WATERLOO METRO QUARTER – SUPPLEMENTARY DESIGN REPORT

Amending SSDA	
Reference	Description
Applicable SSD Applications	SSD-10437 Southern Precinct SSD-10437 Cope Street Plaza Public Domain SSD-14438 Shared Basement SSD-10439 Central Precinct SSD-10440 Northern Precinct
Author	Hassell David Tickle
Reviewed	Waterloo Developer Pty Ltd Matt Rawlinson
Document Number	WMQ-SITE-HAS-UD-RPT-RTS-001
Status	Draft
Version	02
Date of Issue	12 March 2021

This Supplementary Design Report addresses objections to the amending application raised by the City of Sydney in their submission with specific reference to building envelope aspects of items 14.a, 14.b and 18 raised by the City of Sydney in its submission Response to EIS – Waterloo OSD – SSD 10441.

Figure 2.1.1. Plan showing change in extent of potential shadow impact to adjacent developments on 21 June at 9am.

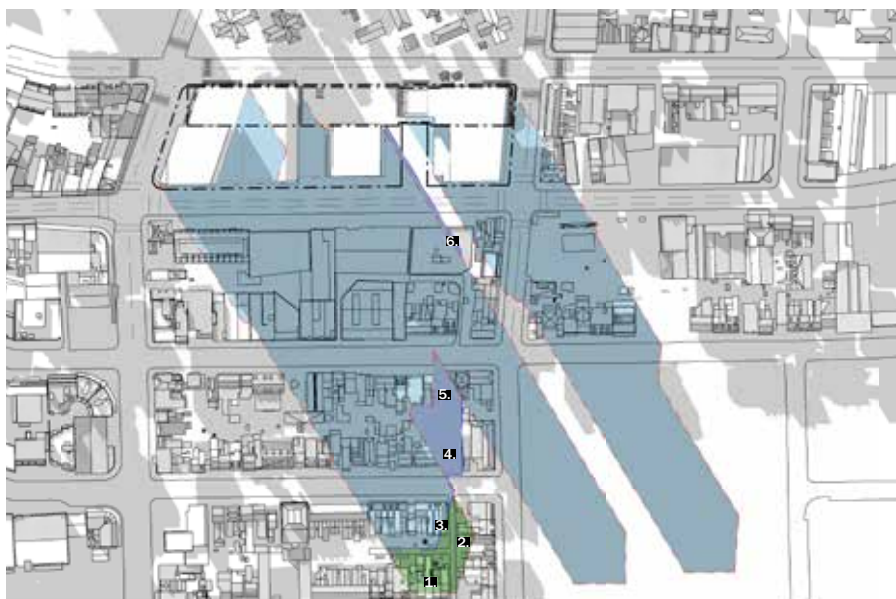
- living room windows of neighbouring developments are not included in the assessment provided of overshadowing impact;
- The analysis focuses on the Heritage Conservation area which now have a reduced impact as a result of proposed modifications to the envelope.
- The impact on properties to the south of the site are not addressed in provided reporting; these should be addressed as the design quality and amenity guidelines do not distinguish between residential properties in or outside the heritage precinct when requiring amenity to be properly provided to adjacent residential development.

Figures 2.1.1-2.1.7 following demonstrate that overall, potential overshadowing to surrounding residential dwellings has been reduced throughout the day where the amendments to the concept application are proposed.

Alexandria Park SSD9393 Shadow
 Analysis Baseline June 21st 9am-10am

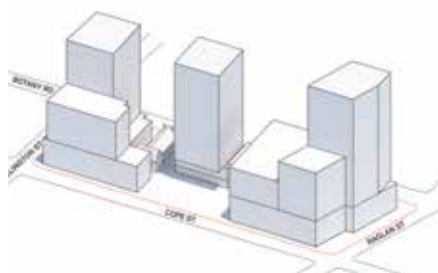
- The City of Sydney notes that whilst the analysis provided achieves compliance with the requirements of the design guidelines, the Amending Application has provided only a minor reduction to the projected overshadowing of Alexandria Park between the specified time of 9am-10am on the winter solstice compared to the approved concept design.
- The City of Sydney has interpreted the guidelines as anticipating a greater reduction to overshadowing than that provided under the amended application.
- The City of Sydney has suggested that a better urban design strategy would be to reduce the height of building envelopes where 'non-compliant' overshadowing occurs, being the tower envelopes for buildings 2 and 3.

Analysis of this model has identified that the areas of concern for overshadowing of any building is restricted to buildings 2 and 3 between 9am-9:30am and at 10am on 21 June.

The baseline boundary survey information provided as part of the competitive tender process by Sydney Metro was oriented to MGA North which does not provide an accurate representation of shadows cast by the approved envelopes or potential buildings within the envelope.

Reliance on the embedded North within the cad file provides a false assessment of impact with extent of impact increasing once the north orientation is corrected as provided under 'Baseline Solar Analysis 02'.

Analysis of number of hours sunlight to the facade of Building 02 on 21 June, 9am-3pm

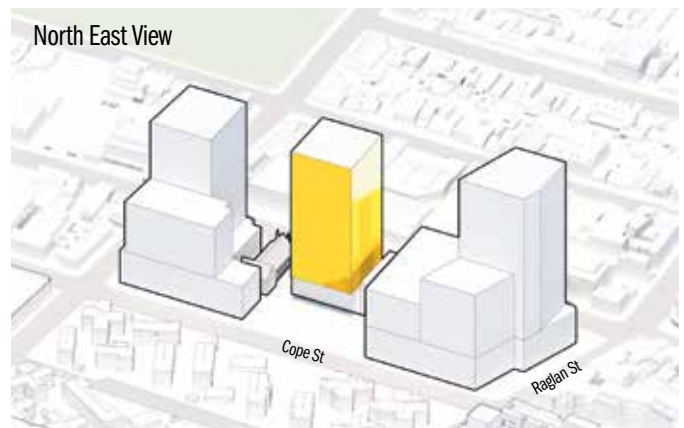
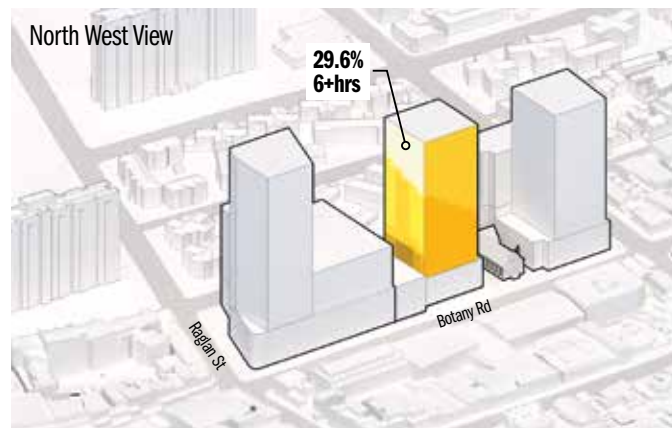
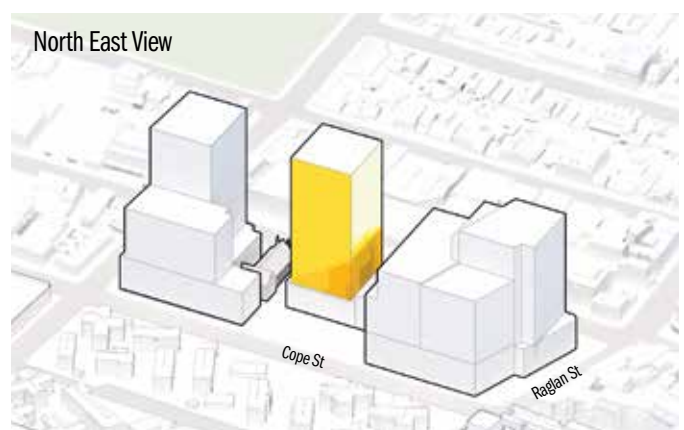
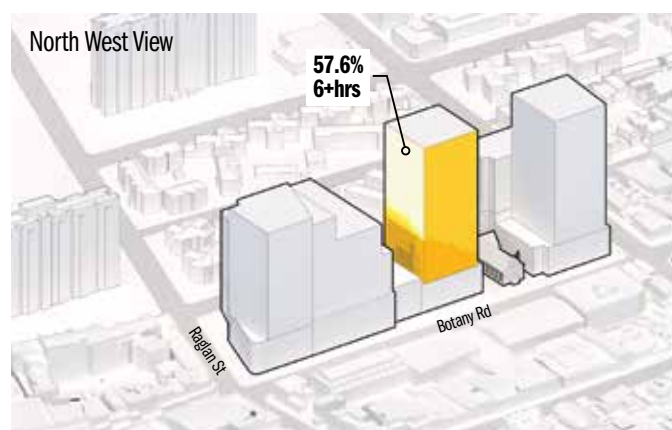
- Solar access – Objective 4A-1 of the Apartment Design Guide (ADG) recommends, as a minimum, 70% of apartments be provided solar access to living rooms and balconies for at least two hours during midwinter. The application states that 57% of apartments achieve the design criteria. The City does not support the applicant's justification for the non-compliance by including solar access after 3pm as this is not reflected in the design guidance or criteria and is of little thermal benefit due to the low altitude of the sun.
- The non-compliance is a symptom of the site planning, locating the commercial office building adjoining the northern boundary and obstructing solar access to the residential apartments to the south. The City therefore raises concerns with the appropriateness of SSD-10441 regarding Objectives 3A-1, 3B-1 and 4A-1 of the ADG.

In raising objections with the compliance of the proposed Building 02 design under SSD-10439 with solar access requirements, the City of Sydney identifies the changes in envelope under the amended proposal as being a cause for non-compliance.

The analysis provided on the adjacent page demonstrates that on the winter solstice, the amended envelope results in a significant decrease in overshadowing of Building 2 by Building 1.

As such, the City of Sydney's suggestion that non-compliance of the Building 02 design as a result of the primary building envelope changes proposed under SSD 10441 is not deemed accurate.
